HONOLULUTRAFFIC.COM

November 4, 2009

RE: Honolulu High-Capacity Transit Corridor Project

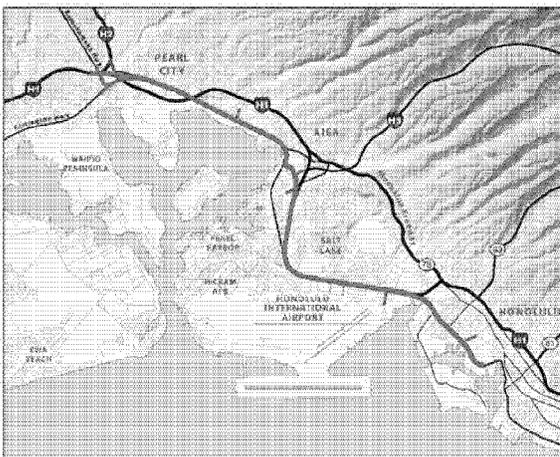
We believe that the Managed Lanes Alternative (MLA), rejected by the City subsequent to completion of the Alternatives Analysis (AA) is a "feasible and prudent avoidance alternative" preferred in the Section 4(f) process. The final exit/entrance for the MLA is near Pier 16 and thus avoids most of the significant 4(f) properties (see map below).
